obudowa przekładni Makita 459216-8 (nowy numer 413828-1)

D8475

Title	Change of Brush A complete, Gear housing, Brush stopper Addition of Earth plate A
Model	DSL800, XLS01
Country	All countries
Description	For countermeasure against static electricity: • Brush A complete, Gear housing and Brush stopper will be changed. • Earth plate A will be added.

[3] Change of Brush stopper

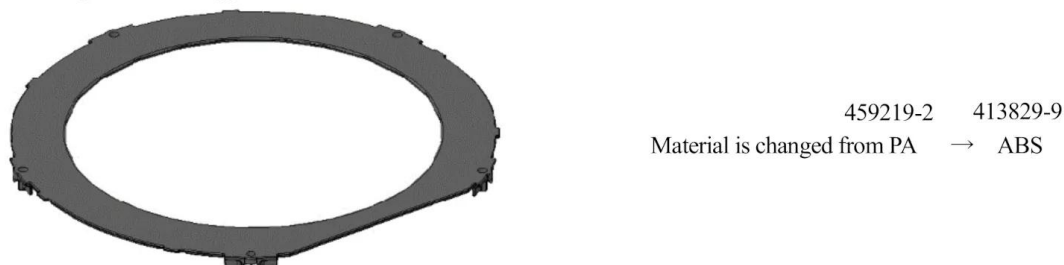
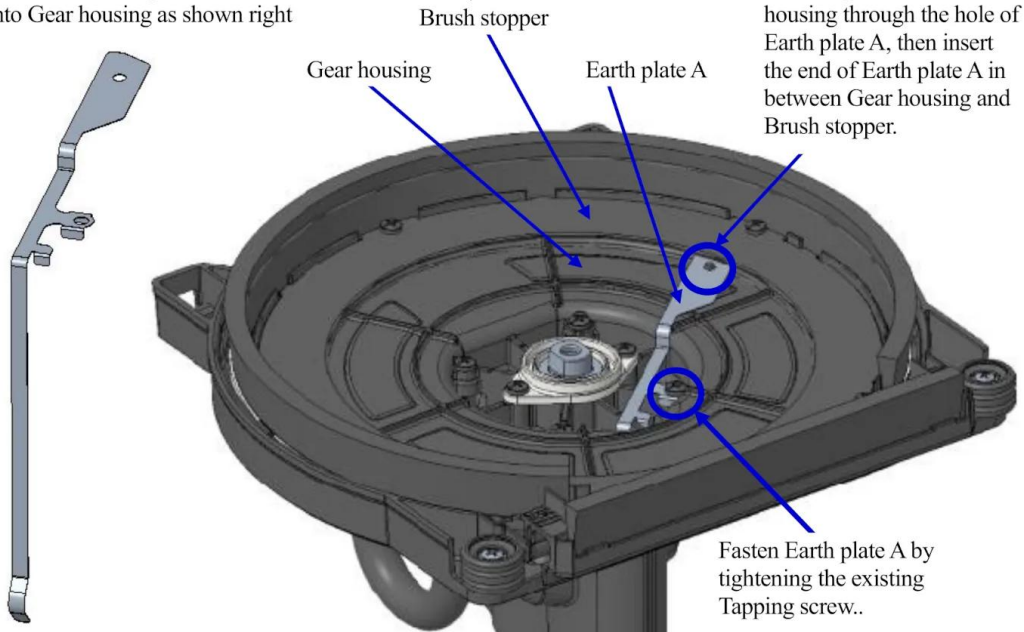
[4] Addition of Earth plate A 347816-5
into Gear housing as shown right

Item No.	Current part	Q'ty	I/C	H/S	S/P	New part	Q'ty	Note
[1]	043	BRUSH A COMPLETE 140J85-5	1	S	OK	A	BRUSH A COMPLETE 141C96-1	1	Interchangeable as a set
[2]	029	GEAR HOUSING 459216-8	1	S	OK	A	GEAR HOUSING 413828-1	1	
[3]	040	BRUSH STOPPER 459219-2	1	S	OK	A	BRUSH STOPPER 413829-9	1	
[4]	094			S			EARTH PLATE A 347816-5	1
